Fakir Fashion Ltd.(Extension)

21st June 2017

Building Information

Column layout of Part A

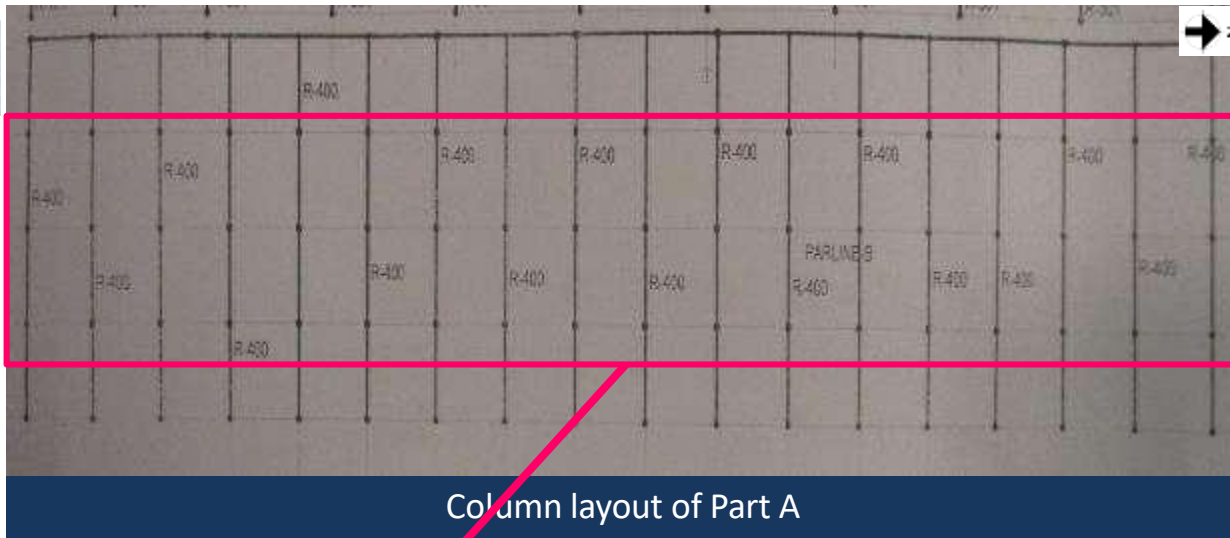
In the marked zone, two steel pipe columns had found instead of three steel pipe columns. Factory is required to update the as-built drawing and assess the stability against vertical and horizontal load.

Bracing layout of Part B

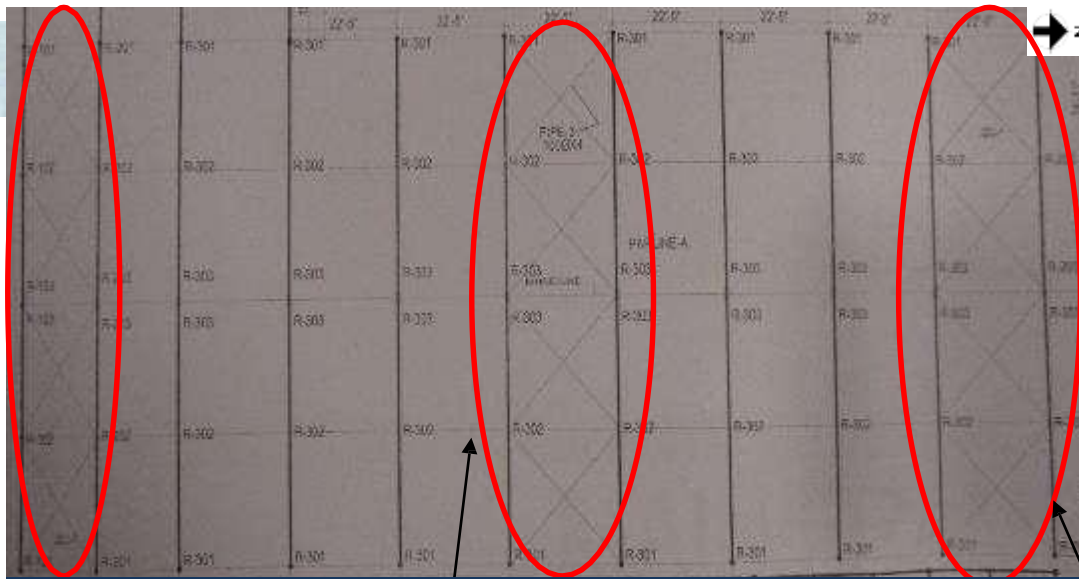
No horizontal bracing was found on site where as in provided drawing, the horizontal pipe bracings were shown. Factory is required to install the bracing according to structural drawing.

No horizontal pipe bracing was observed

Missing bolt and loose connection on Part B

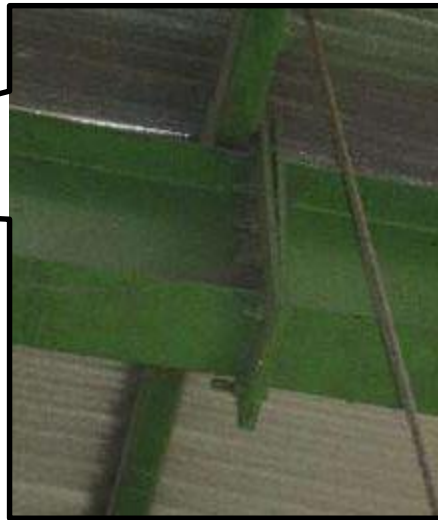
Loose connections were found in several locations in Part B which may produce excessive shear stress in the bolt. The factory is required to take necessary steps for tightening the connection.

Missing bolts were found in column rafter joint.

Column layout of the Part B

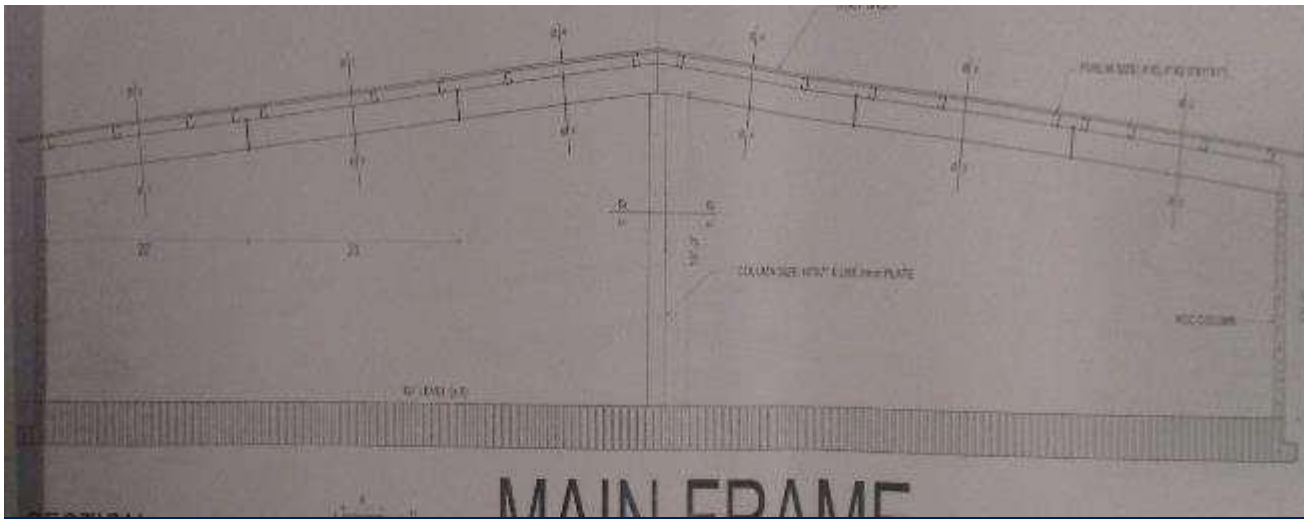
Column top broken at the joint of rafter at north end bay

Column top broken at the joint of rafter at south end bay

On the end bay, some portion of the top of RCC column was found broken. The factory engineer is required to assess the capacity of the column and rafter against vertical and lateral load as rafter not properly rested on column.

Load combination used in analysis

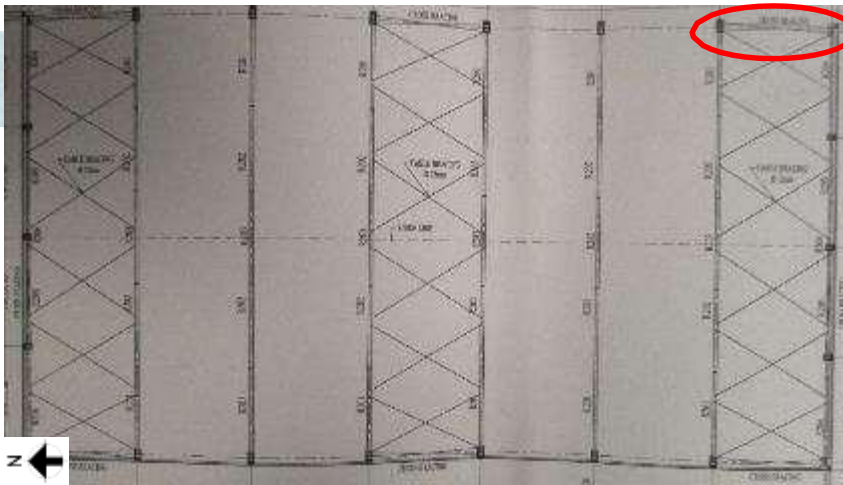
Factory provided DEA report for the shed during inspection where factory engineer assessed the shed without earthquake loading. In addition, factory could not provide any FEA model for the shed.

Factory is required to revise the report with considering the earthquake in load combination and discrepancy which are mentioned earlier and submit the report to ACCORD for further review.

Bracing layout in provided drawing

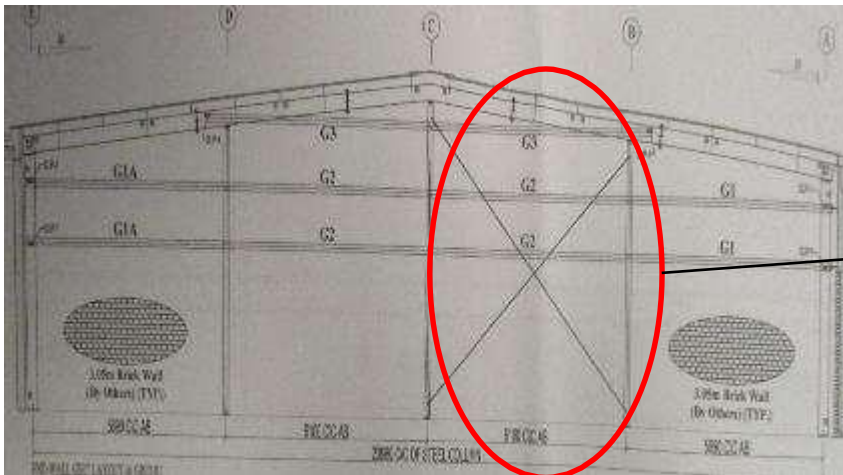
No vertical bracing was observed on east side

Vertical bracing in provided drawing

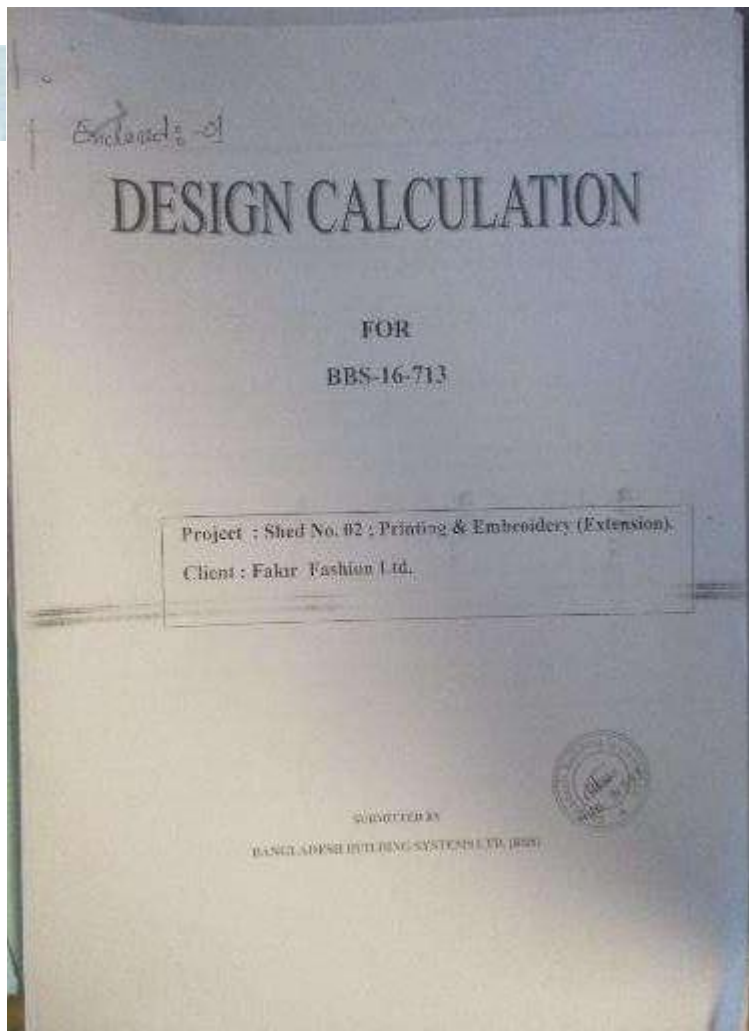
The location of vertical bracing was not matched with provided drawing.

Retrofitting recommendation in DEA report

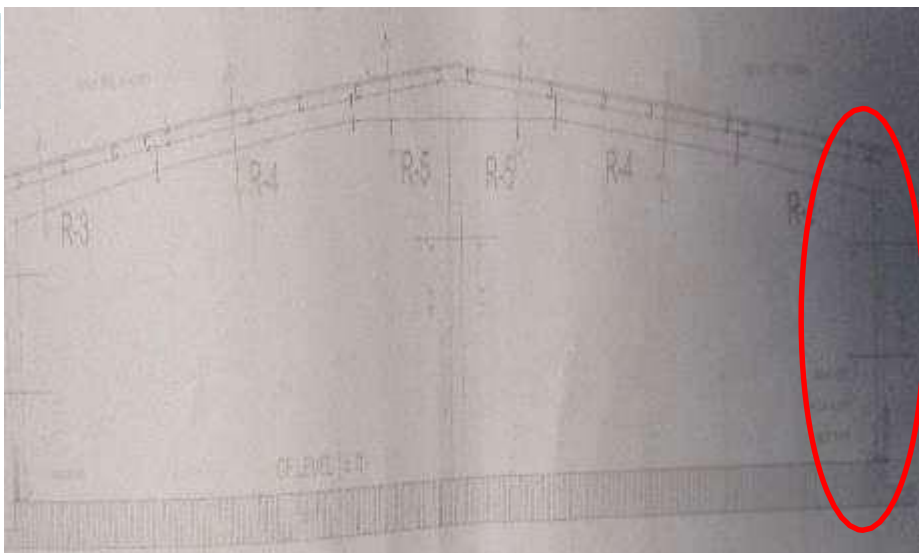
According to the provided DEA report, considering mezzanine floor, the angle bracing and addition of stiffener with the main beam is recommended. But retrofitting drawing was not provided along with the report. For that, DEA report is required to review by ACCORD. Factory is required to revise the report according to earlier mentioned discrepancy and submit to ACCORD for further review.

Portal frame in provided drawing

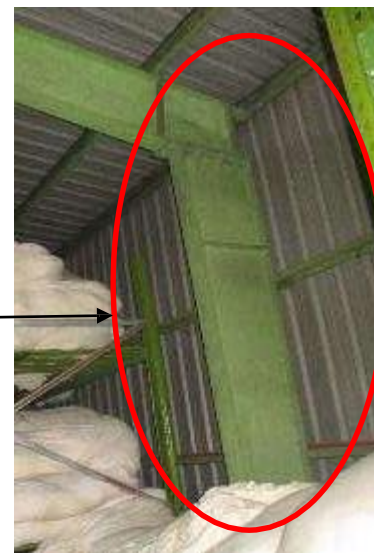
Edge columns were found tapered whereas in provided drawing, those column were shown as straight section.

Roof bracing layout in provided drawing

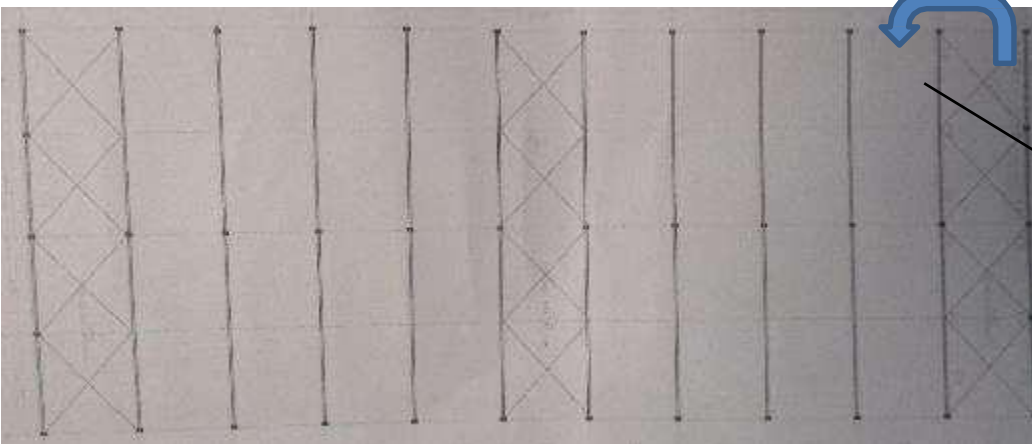
Roof bracing were found installed different location and not as per provided drawing.

Typical internal truss frame

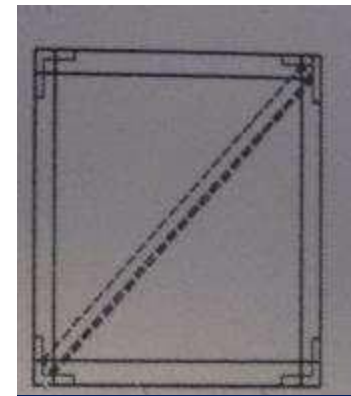
Section of steel truss frame was not present in provided drawing. Also, no joint detail and column section was observed in the drawing. Factory is required to update as-built drawing and check the capacity against lateral and vertical load.

Capacity check for customized steel racks

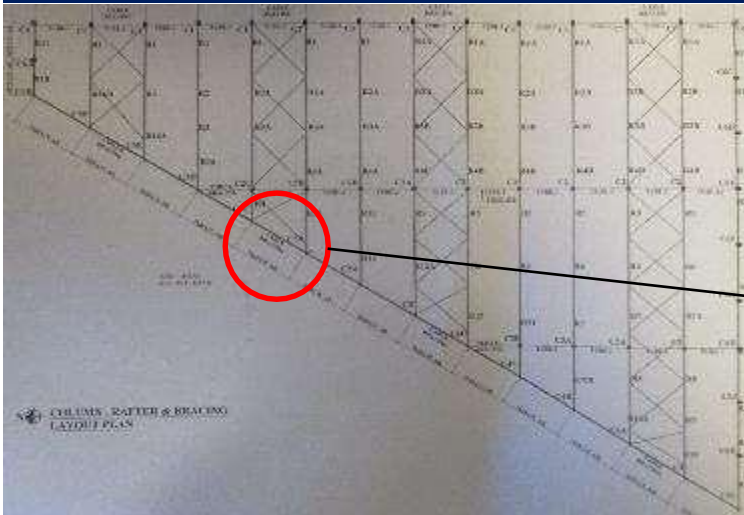
Customized steel racking system is used for storage with an upper platform over the entire area. There was no specific loading plan for the rack supported floors. A capacity check should be carried out for a specific live loading limit.

Loose and missing bracing

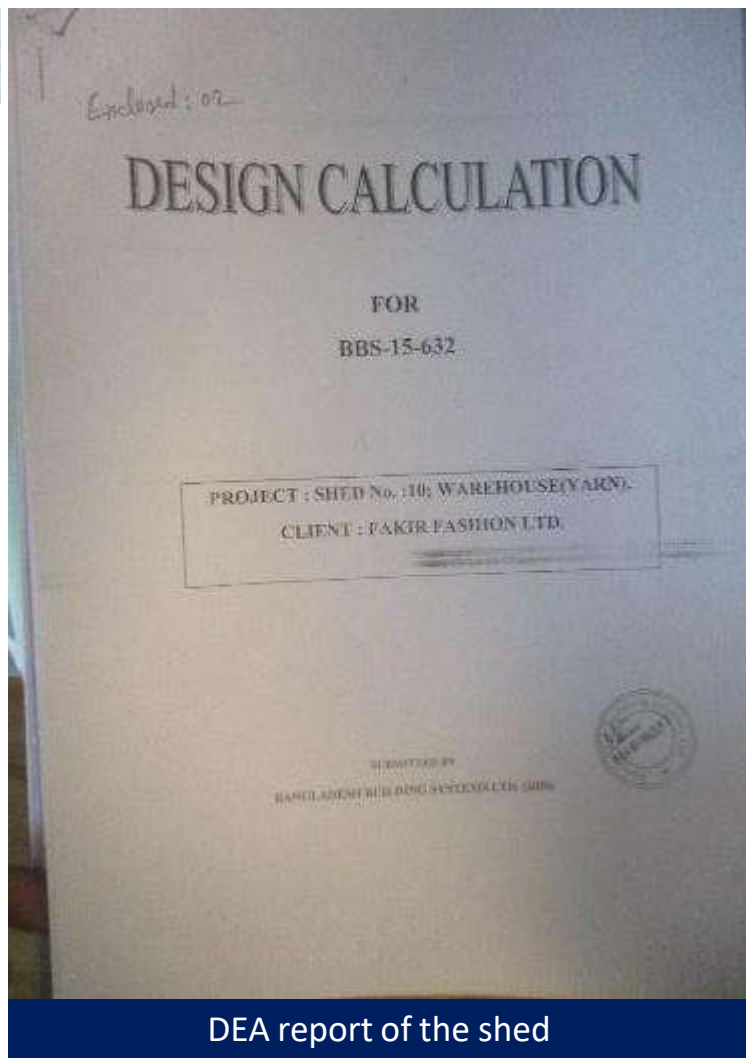
Most of the vertical and roof bracings had found loosely tied. The loose bracings are required to be tighten for acting as a part of stability system.

Vertical bracing was found missing in one location. Factory is required to install the bracing according to the drawing.

Retrofitting recommendation in DEA report

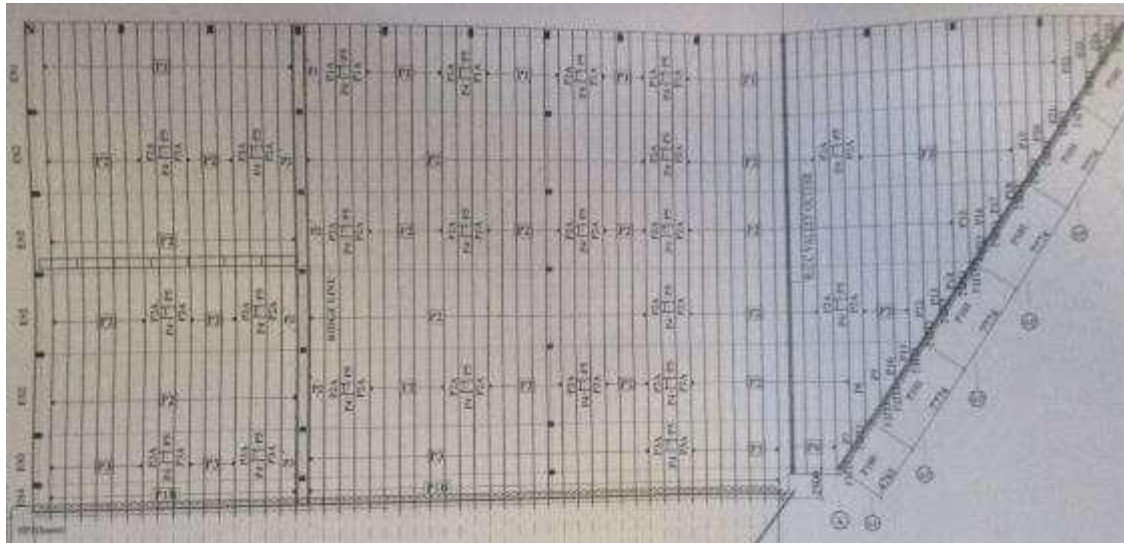
According to the provided DEA report, considering mezzanine floor, the angle bracing and addition of stiffener with the main beam is recommended. But retrofitting drawing was not provided along with the report. For that, DEA report is required to review by ACCORD. Factory is required to revise the report according to earlier mentioned discrepancy and submit to ACCORD for further review.

Capacity check for customized steel racks

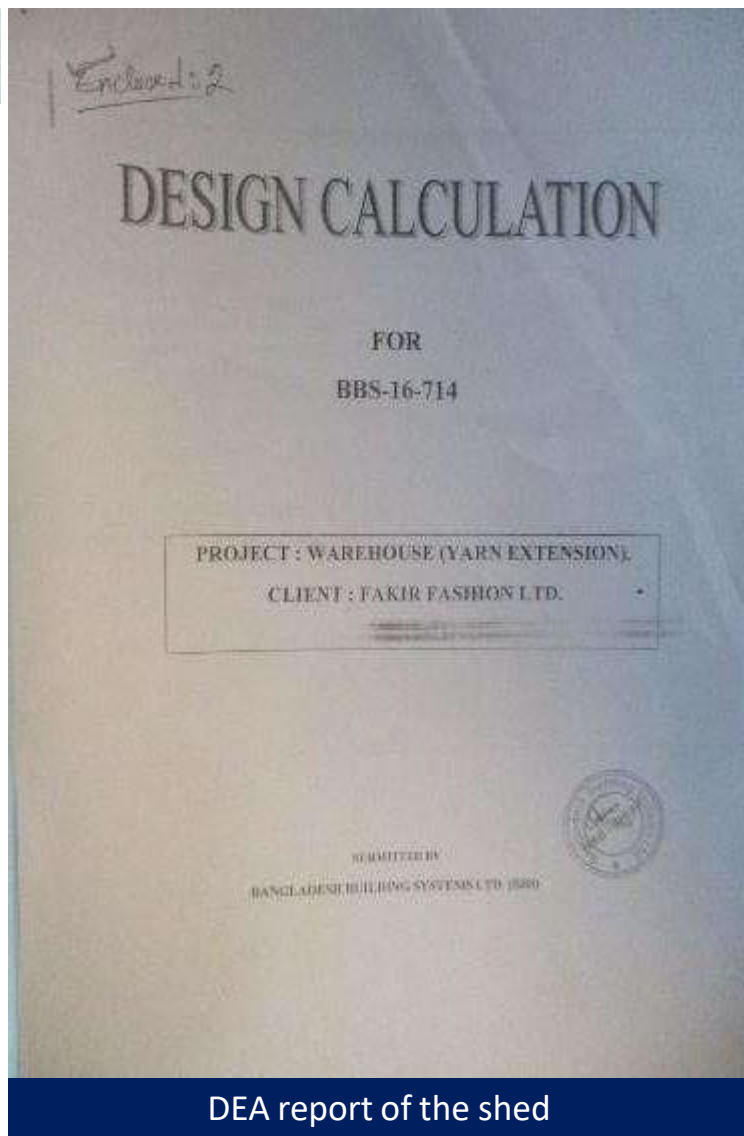
Customized steel racking system is used for storage with an upper platform over the entire area. There was no specific loading plan for the rack supported floors. A capacity check should be carried out for a specific live loading limit.

Retrofitting recommendation in DEA report

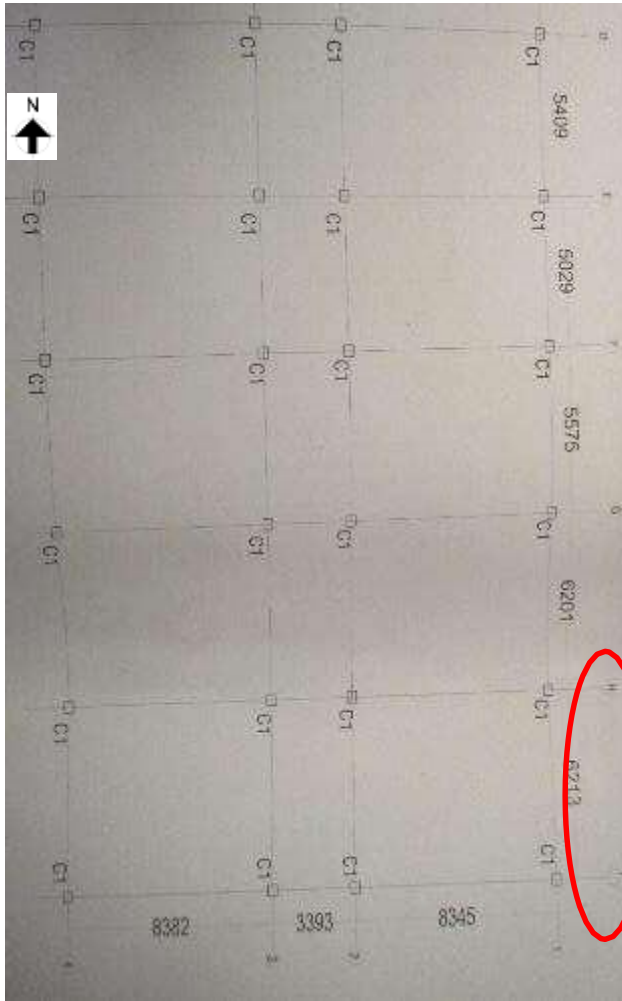
According to the provided DEA report, considering mezzanine floor, the angle bracing and addition of stiffener with the main beam is recommended. But retrofitting drawing was not provided along with the report. For that, DEA report is required to review by ACCORD. Factory is required to revise the report according to earlier mentioned discrepancy and submit to ACCORD for further review.
